STONE GATE SUBDIVISION, **RESUBDIVISION OF LOT 19**

APPLICATION NUMBER 20 DATE June 21, 2007

DETAIL SITE PLAN

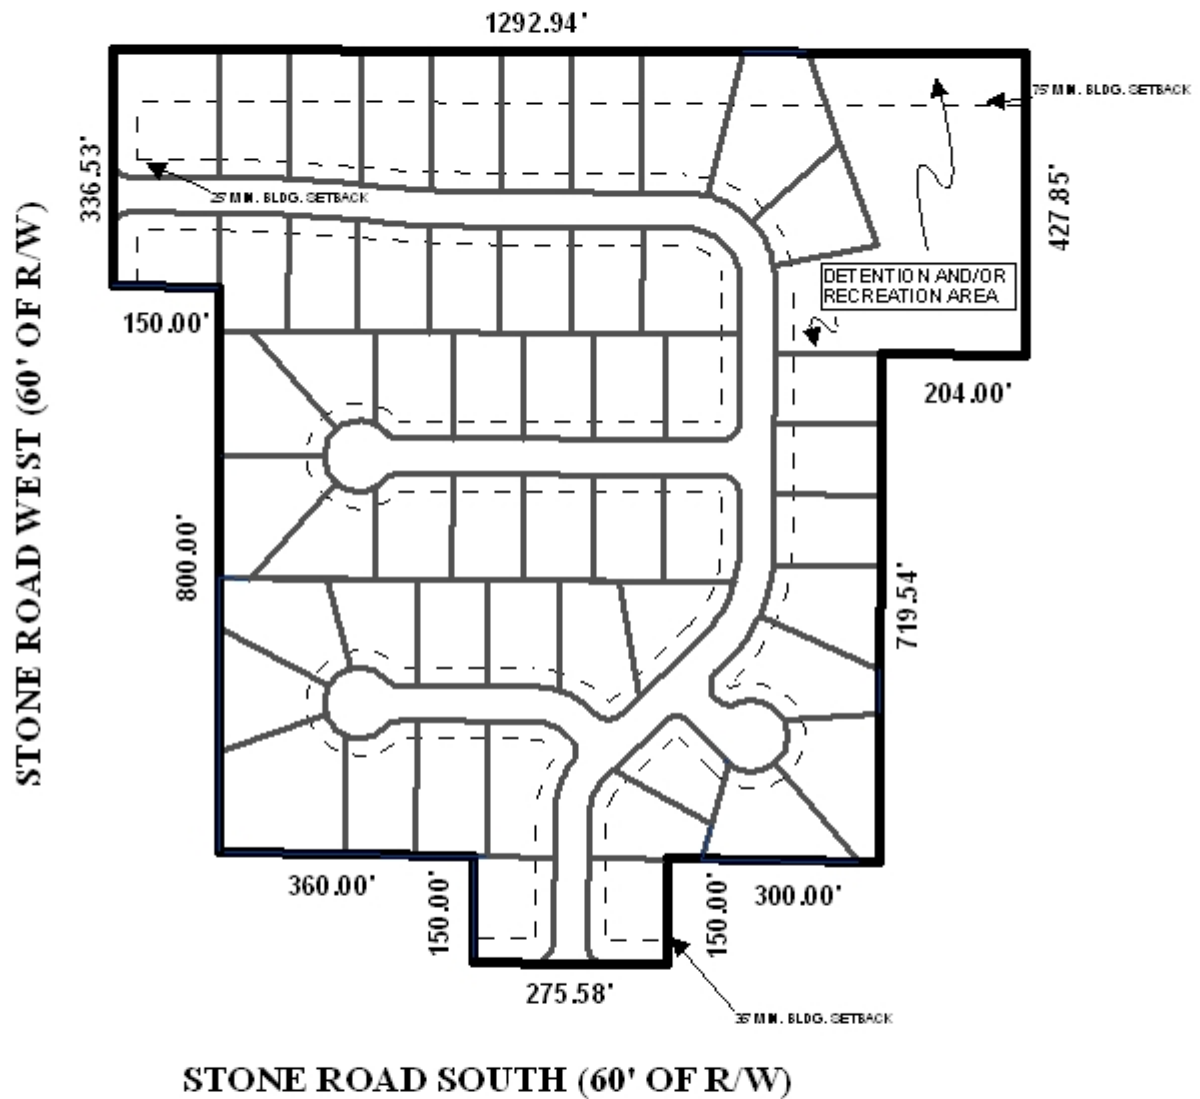
The site fronts Stone Road South and Stone Road West, both minor streets, illustrating 60-feet of right-of-way for both streets. The minimum right-of-way width for minor streets lacking curb and gutter, such as Stone Road South and Stone Road West, is 60 feet; therefore, the existing right-of-way meets the required minimum width standards as required by Section V.A.14. of the Subdivision Regulations. The site also fronts a future major street (Eight Mile Creek Parkway), as illustrated on the Major Street Plan component of the Comprehensive Plan, which requires a 100-foot right-of-way.

The plat provides two points of access for the proposed lots, one each to Stone Road West and Stone Road South. The plat also depicts a 75' setback from the future major street (Eight Mile Creek Parkway), which runs along the North boundary of the Subdivision; this would provide for a 25' building setback, as well as the needed 50' right-of-way from the centerline. Access management is a concern; thus the placement of a note should be required on the final plat, stating that direct access is denied to Eight Mile Creek Parkway for Lots 20-28.

The new roads for the site are to be dedicated and constructed to meet County Engineering Standards. Additionally, since Lots 4, 5, 19, 20, 34, 37, 39, 48, 50, 63 and 64 are corner lots, a note should be placed on the Final Plat stating that Lots 4, 5, 19, 20, 34, 37, 39, 48, 50, 63 and 64 are limited to one curb-cut each with the size, design and located to be determined by County Engineering.

One area of concern is the possibility of acquiring the 50-foot for the construction of the future major street (Eight Mile Creek Parkway) would decrease the size of the lots along this proposed right-of-way. The Subdivision Regulations require 15,000 square feet for lots that are served by public water or an improved private water supply system and individual sanitary sewage (septic) system. However, it is illustrated on the preliminary plat that all lots do meet the minimum size requirements for developments with access to public water and individual sanitary (septic) sewer

as required in Section V.D.2. of the Subdivision Regulations. Therefore, a waiver of Section V.D.2. of the Subdivision Regulations may be appropriate, due to the time frame of the actual acquisition and construction of the future major street. Possibly, the entire subdivision may be served by public sewer by the time of completion of the major street.

Common areas are illustrated on the plat as being either for detention or recreation; thus the placement of a note should be required on the final plat, designating the common area for detention or recreation, and stating that maintenance thereof shall be the responsibility of the property owners. The plat should also be revised to depict lot sizes to be illustrated in square feet either through labeling or the provision of a table on the Final Plat.

The site is located in the County; thus any lots that are developed commercially and adjoin residentially developed property must provide a buffer, in compliance with Section V.A.7 of the Subdivision Regulations.

With a waiver of Section V.D.2. (Minimum Dimensions), the plat will meet the minimum requirements of the Subdivision Regulations and is recommended for Tentative Approval subject to the following conditions:

- 1) the placement of a note on the Final Plat stating that direct access to the future major street (Eight Mile Creek Parkway) is denied for Lots 20-28;

- 2) the placement of a note on the Final Plat stating that Lots 4, 5, 19, 20, 34, 37, 39, 48, 50, 63 and 64 are corner lots, are limited to one curb cut, with the size, design and location to be determined by County Engineering;

- 3) all areas not designated as lots should be labeled as common areas (including wetlands and detention areas), and a note placed on the final plat stating that maintenance of all common areas is the responsibility of the property owners (association);

- 4) submission and approval of individual applications for each phase or unit, to ensure that development occurs in a manner to provide the most points of access in a timely and efficient manner;

- 5) the placement of a note on the final plat stating that any lots which are developed commercially and adjoin residentially developed property must provide a buffer, in compliance with Section V.A.7. of the Subdivision Regulations;

- 6) provision of a certification letter from a licensed engineer to the Planning Section of Urban Development, certifying that the stormwater detention, drainage facilities, and release rate comply with the City of Mobile stormwater and flood control ordinances, prior to the signing and recording of the final plat; and

- 7) labeling of all lots with size in square feet, or placement of a table on the plat containing the lot size information.
